Interactive comment on “Conceptual and numerical modeling of the Guaraní Aquifer System” by L. Rodríguez et al.

L. Rodríguez et al.

Received and published: 12 September 2012

Interactive comment on Hydrol. Earth Syst. Sci. Discuss., 9, 9885, 2012.

Fig. 1.

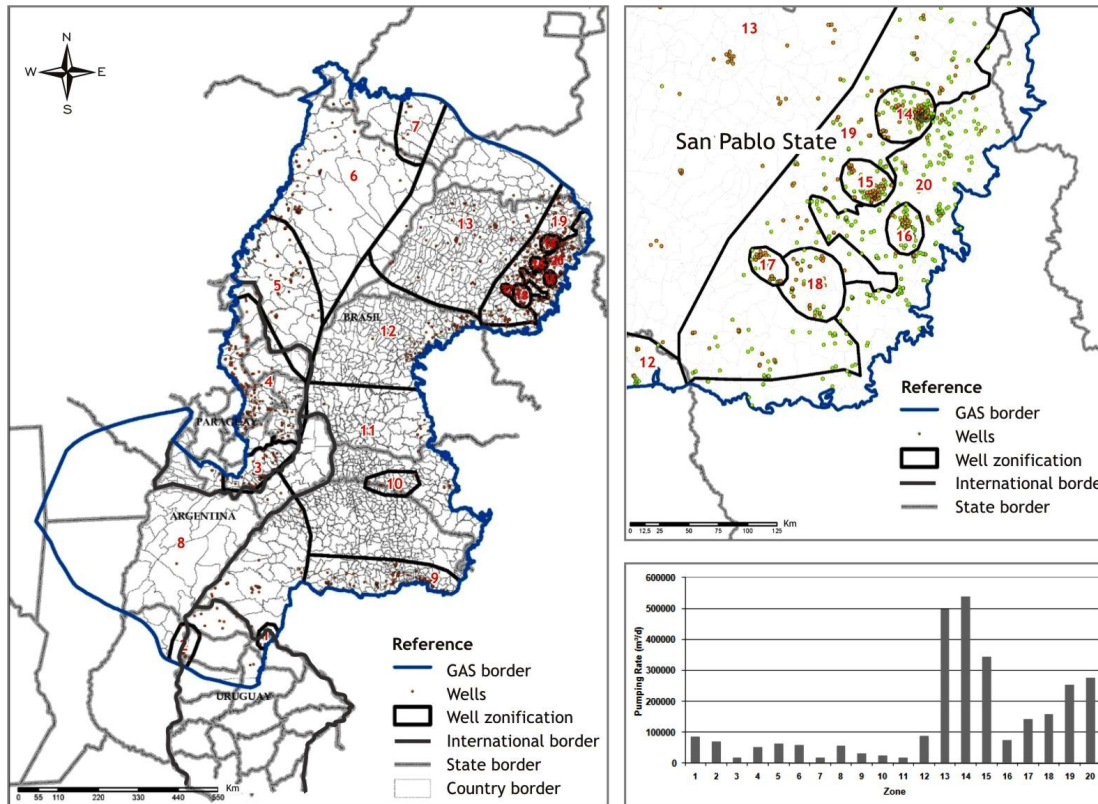
5) Showing the spatial distribution of pumping would be instructive to the readers.

We uploaded a draft figure with this information that will be incorporated in the final version of the manuscript after the discussion period ends.
